# ADDENDUM NO. 1

**October 18, 2022**

## **Additions and Renovations Eastridge Elementary School**

### **TO: ALL BIDDERS OF RECORD**

Site from March 2023 through October 2023

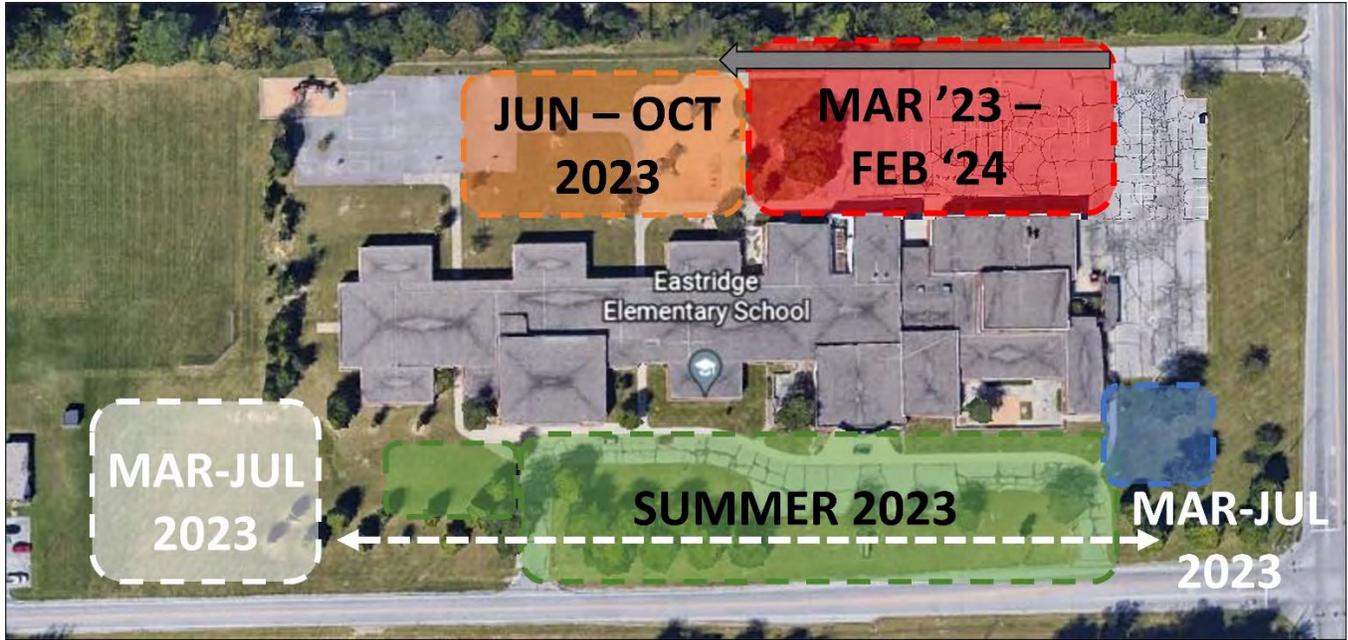
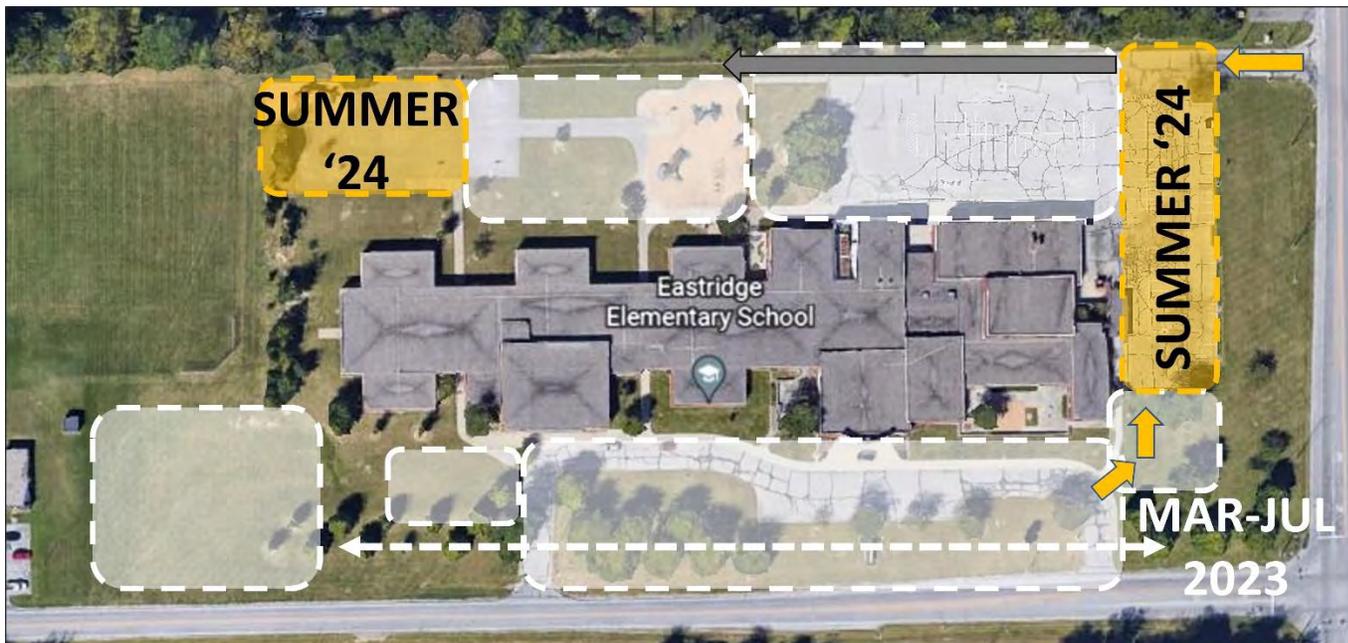
- f. Add: 18. Fences, See Spec. Section 01 32 00 Schedules and Reports, page 7.
    - i. Provide security fence on West, North and East sides of site area indicated in RED from March of 2023 until February of 2024 or minimally until the new bus drop off is turned over to the Owner for use.

- ii. Provide security fence on West, North and South sides of site area indicated in Orange from June of 2023 until October of 2023 or minimally until asphalt paving is complete.

- iii. Provide security fence on ALL sides of site area indicated in WHITE from March of 2023 until July of 2023 or minimally until excavation is backfilled to finish grade.

DRAWING TITLE:  
**PLANTING PLAN**

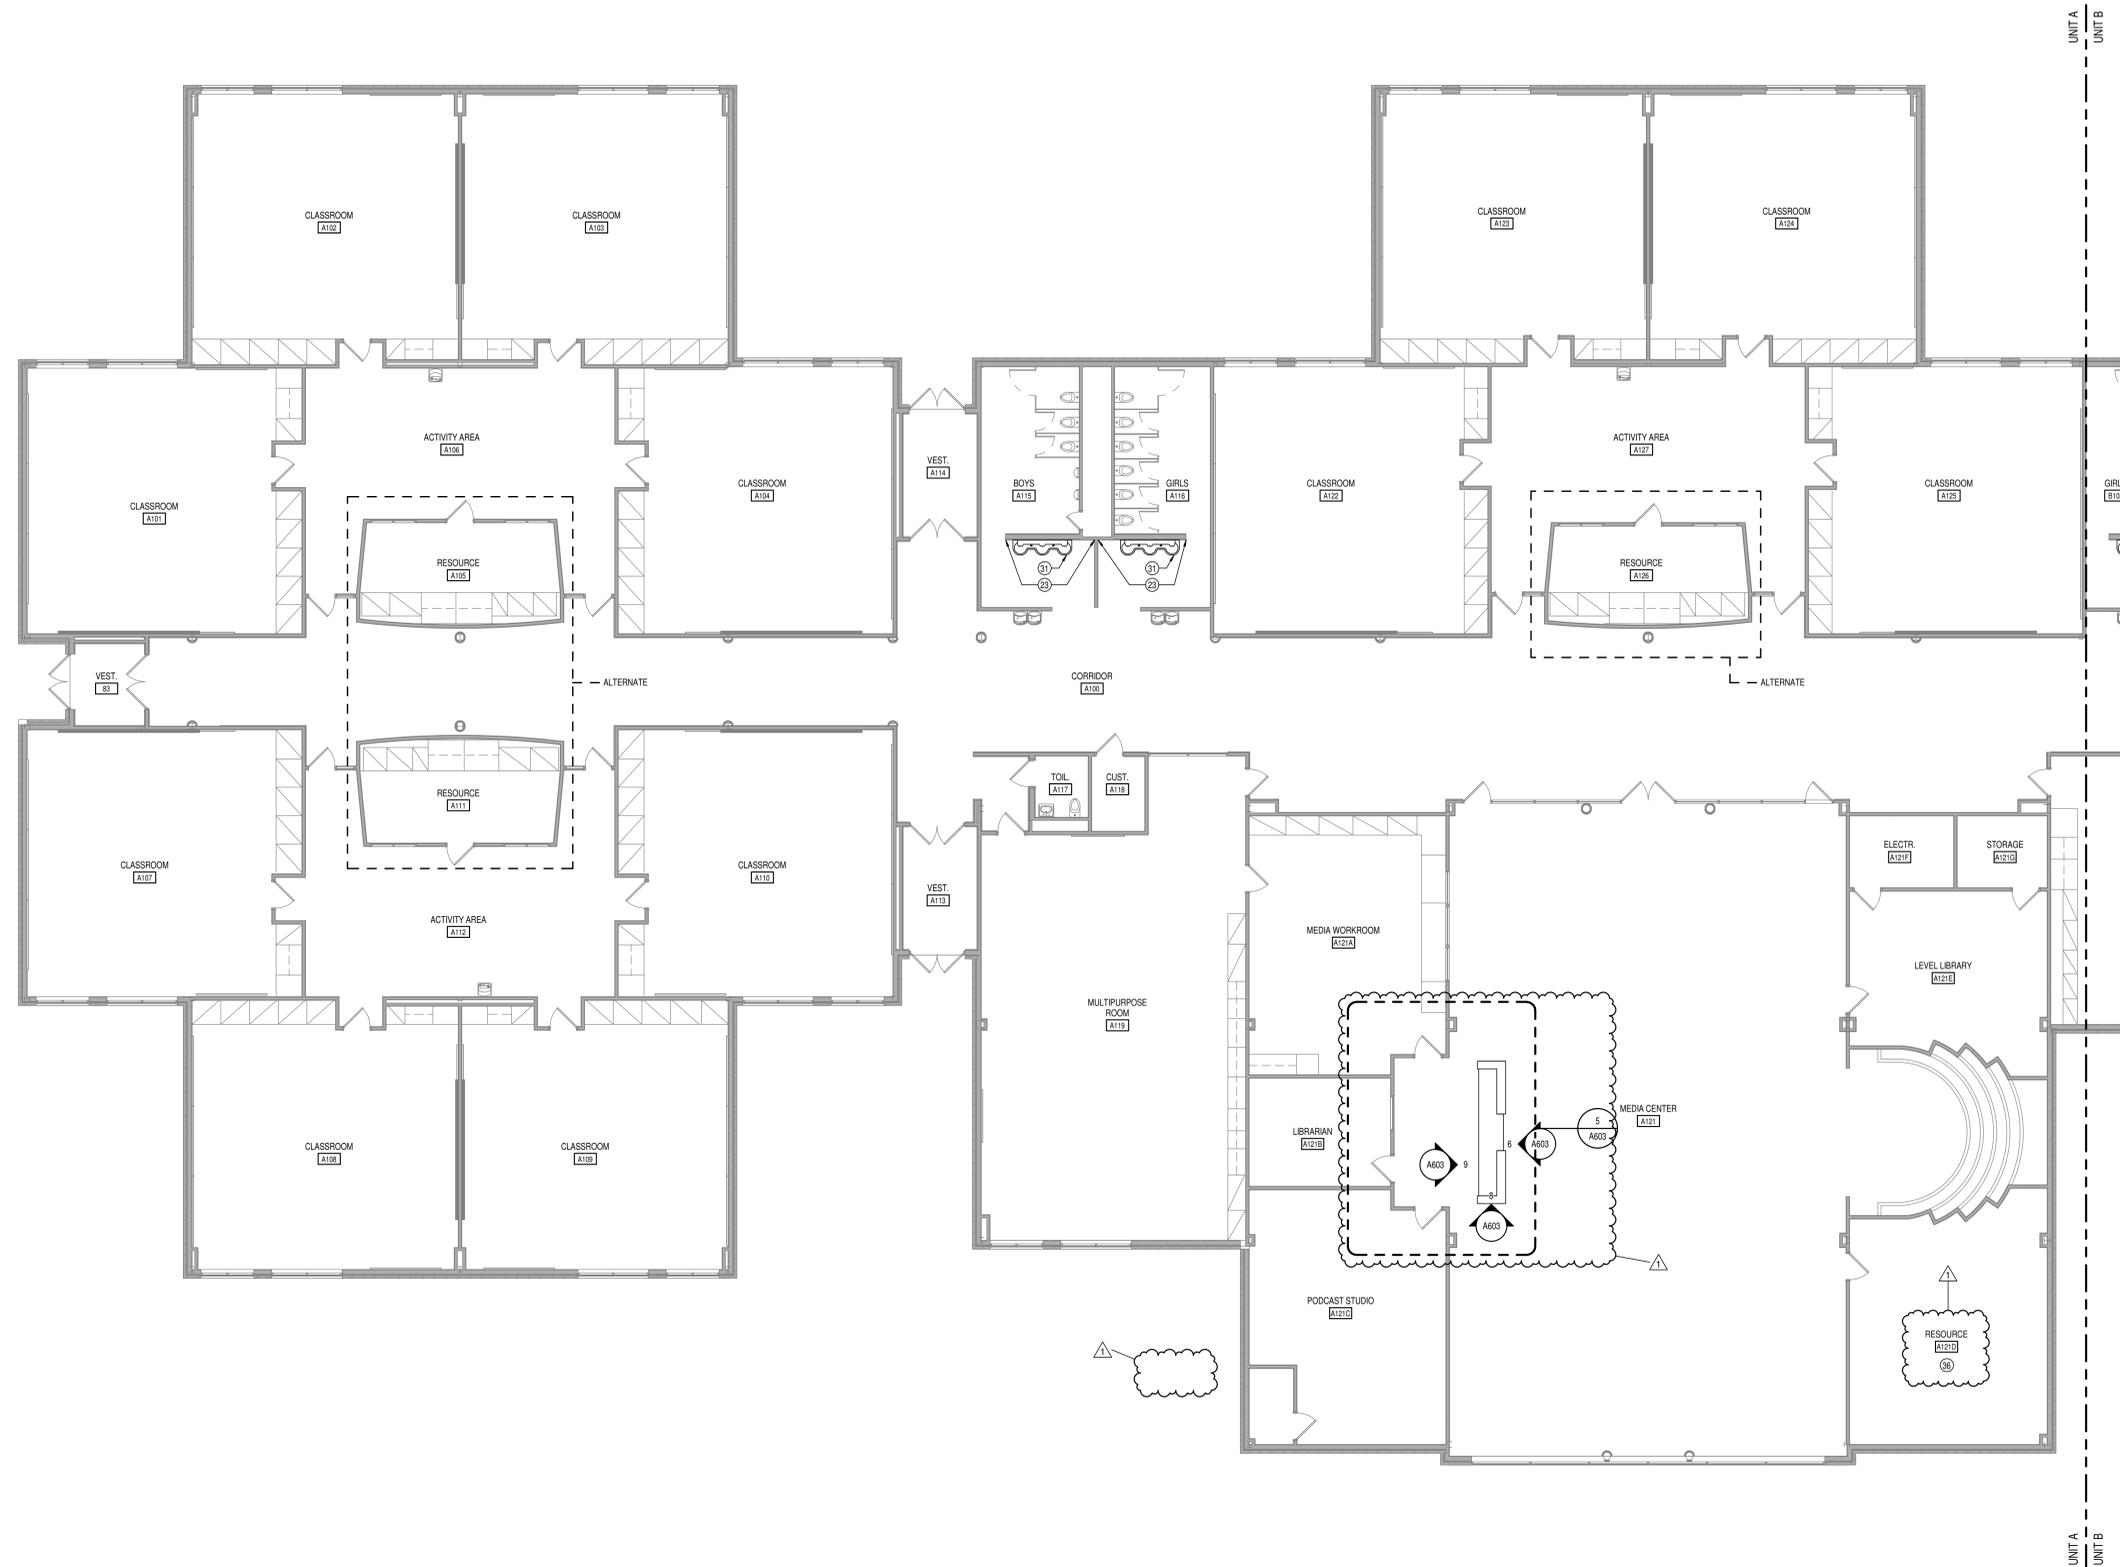
3.2 L302 PLANTING PLAN

- A. Planting Plan updated in response to comments from City Planning, **attached**.

**CERTIFIED BY:**  
**ROBERT J. COOK**  
ARCHITECT  
**DRAWING NUMBER**  
**A201C**  
**PROJECT NUMBER**  
**2021055**

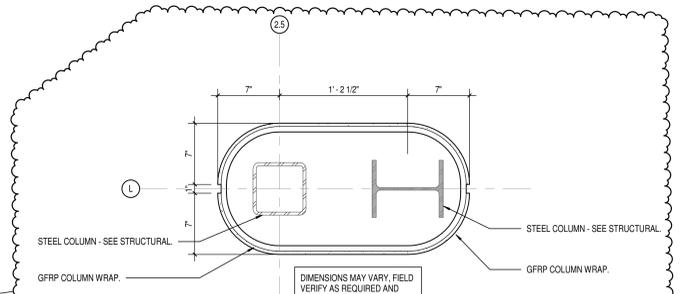
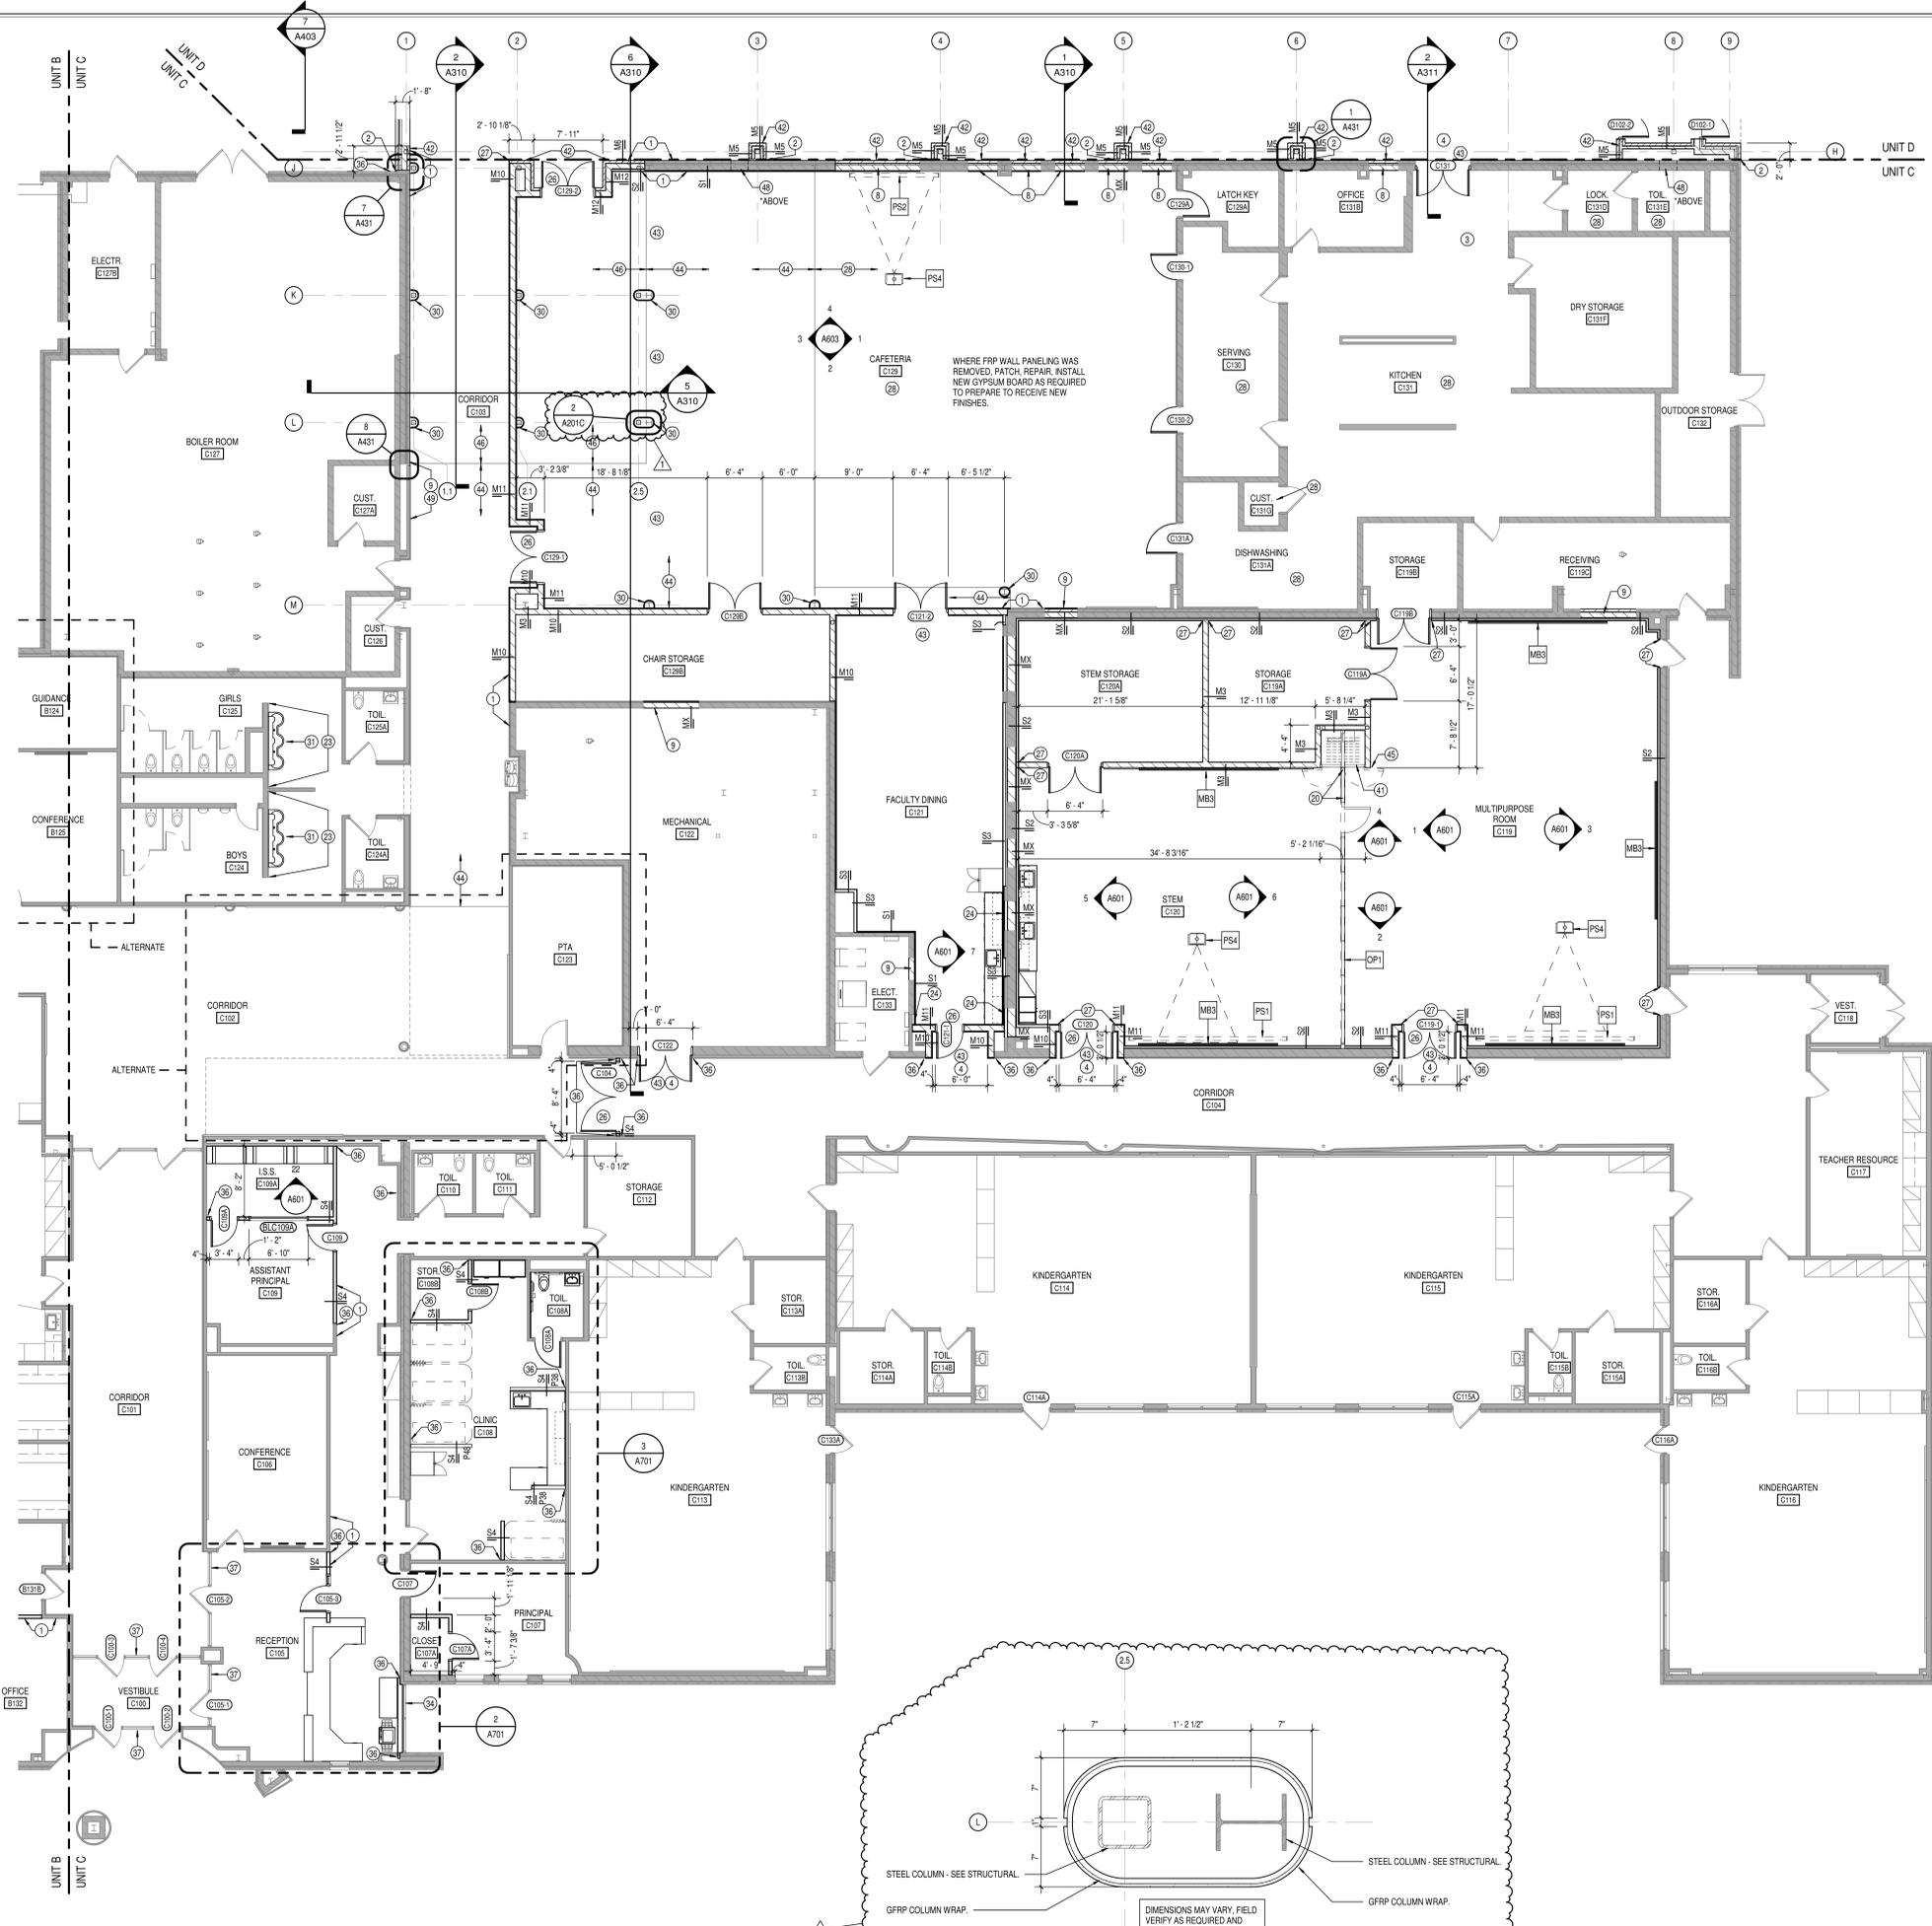
3.5 SHEET A201C – FIRST FLOOR PLAN – UNIT C

- A. Delete and replace entire sheet, **attached**.
- B. Added 2/A201C COLUMN ENCLOSURE DETAIL.

DRAWING NUMBER  
A410  
PROJECT NUMBER  
2021055

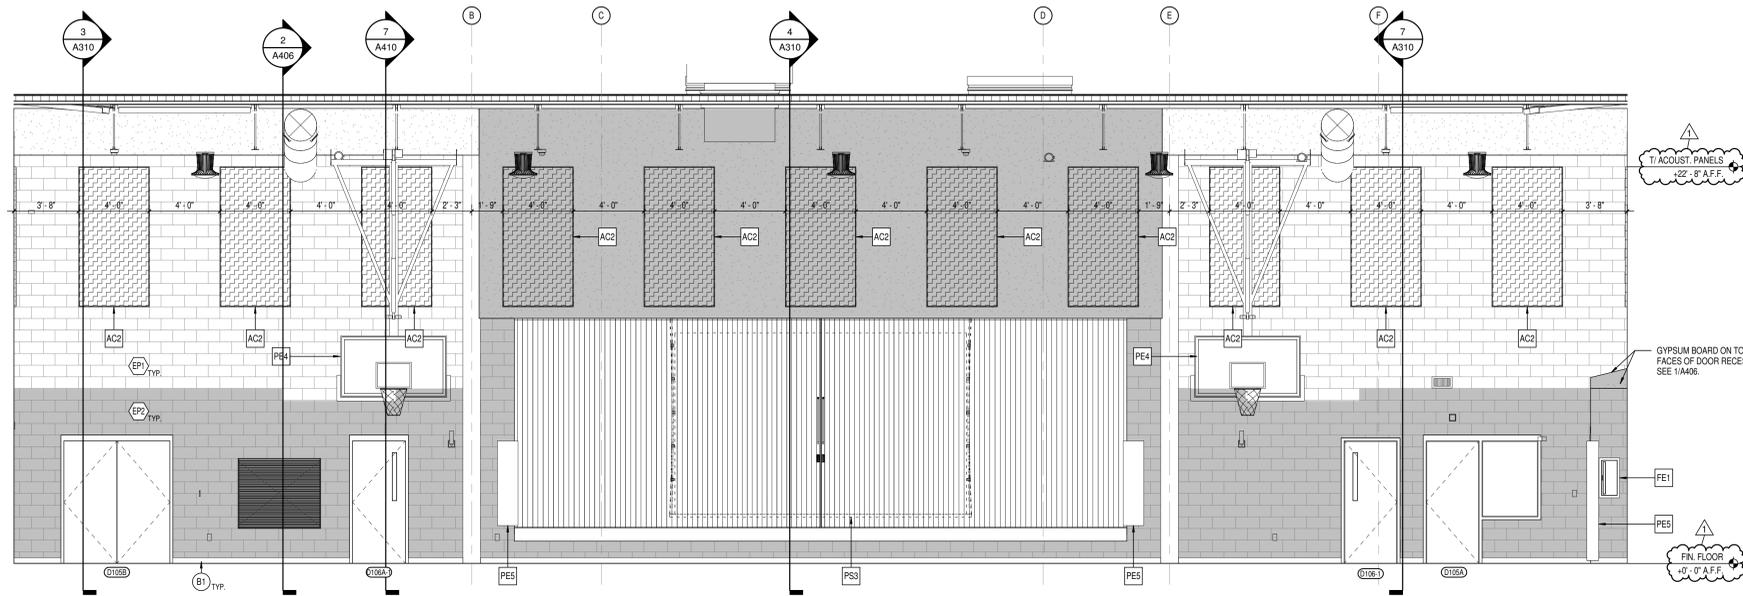
3.7 SHEET A410 – VERTICAL CIRCULATION SECTIONS AND DETAILS

- A. Delete and replace entire sheet, **attached**.
- B. Add CMU wall construction at detail 2/A410
